**City of Portland, Maine – Building or Use Permit Application** 389 Congress Street, 04101, Tel: (207) 874-8703, FAX: 874-8716

Proposed Project Description: (Please be as specific as possible)  
HVAC UNIT REPLACEMENT

PROPOSAL SUBMITTED TO <i>Vermont Transit Co., Inc./Lou Paradis</i>		PHONE <i>772-6587</i>	DATE <i>9/28/98</i>
STREET <i>950 Congress Street</i>		JOB NAME <i>Rooftop Unit Replacement</i>	
CITY STATE AND ZIP CODE <i>Portland, ME 04102</i>		JOB LOCATION <i>950 Congress St. - Portland, ME</i>	
ARCHITECT	DATE OF PLANS	JOB PHONE	
		<i>Doug Avery</i>

## BUILDING PERMIT REPORT

JOB VERMONT TRANSIT

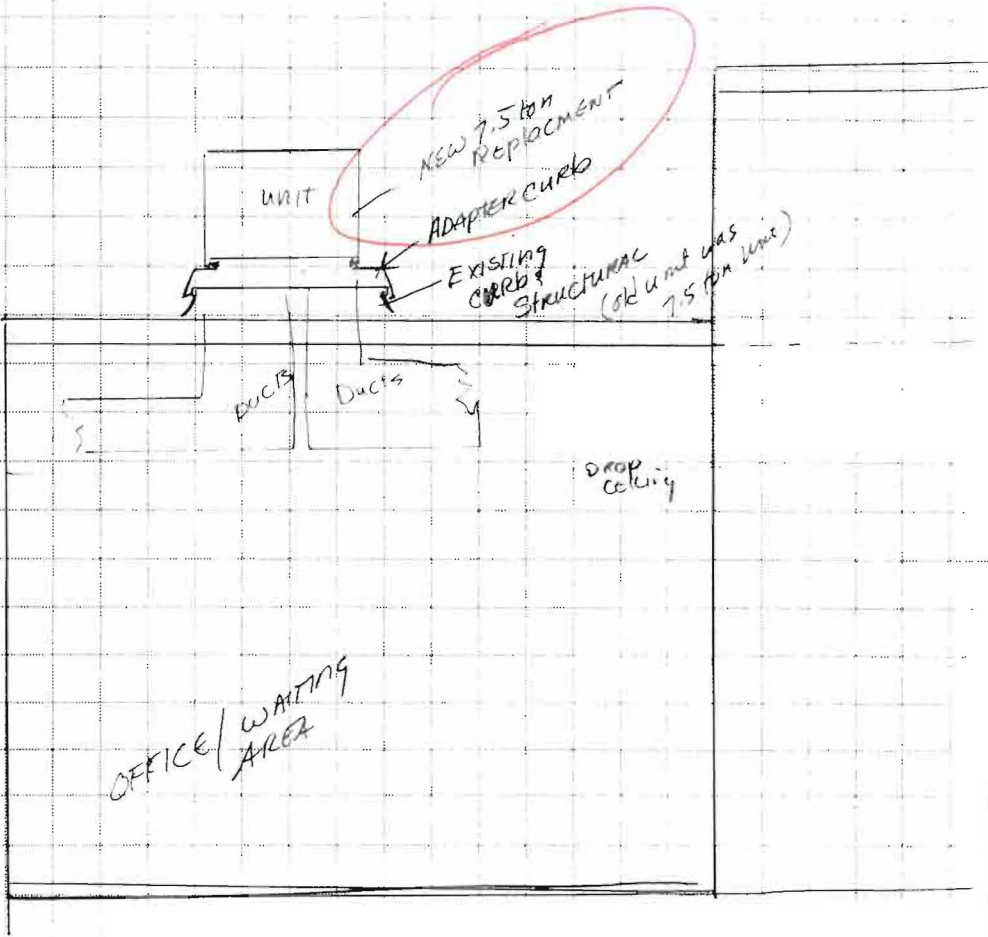
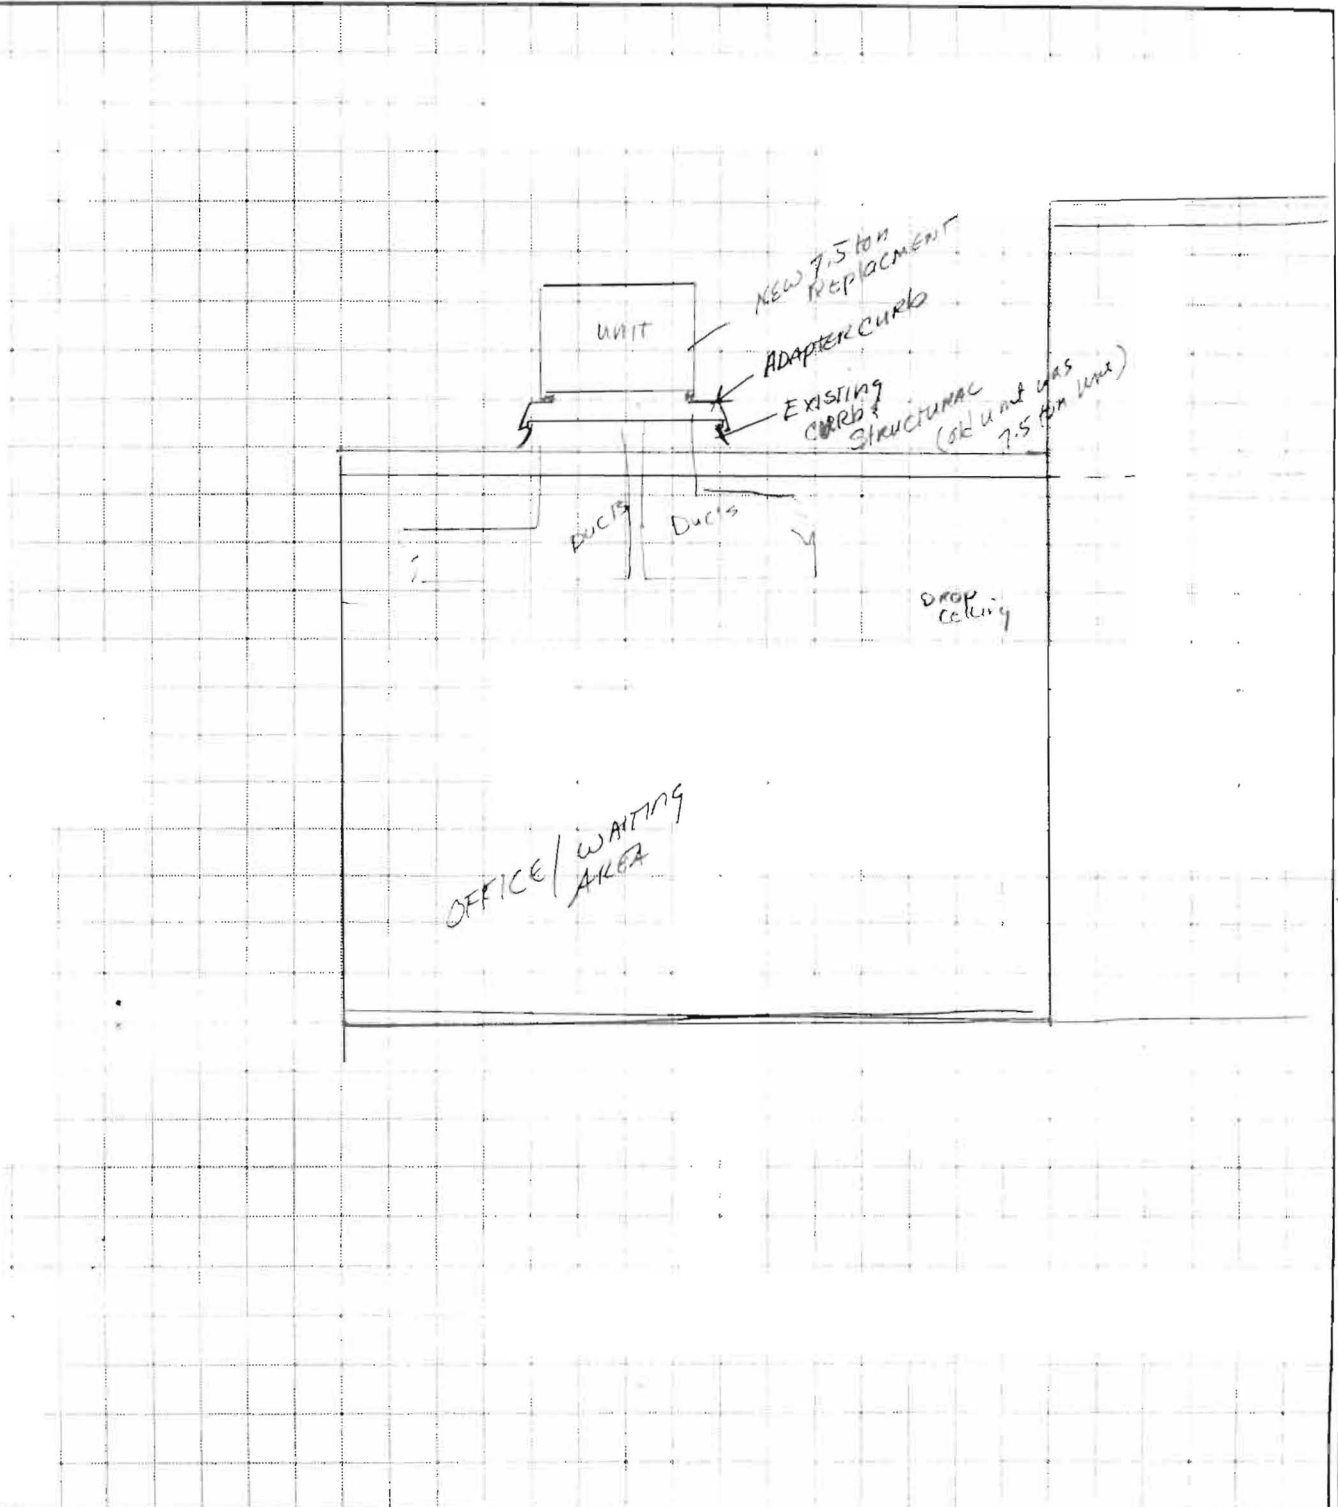
31. I understand that this is a replacement unit. IF The weight increases with the new unit, a structural analysis should be done of the roof system to verify the roof system can carry the new load.

10/12/98 New unit is lighter than old unit  
talked with Doug.

New Unit weighs less than old unit  
so roof should be adequate  
for new unit OK  
mws
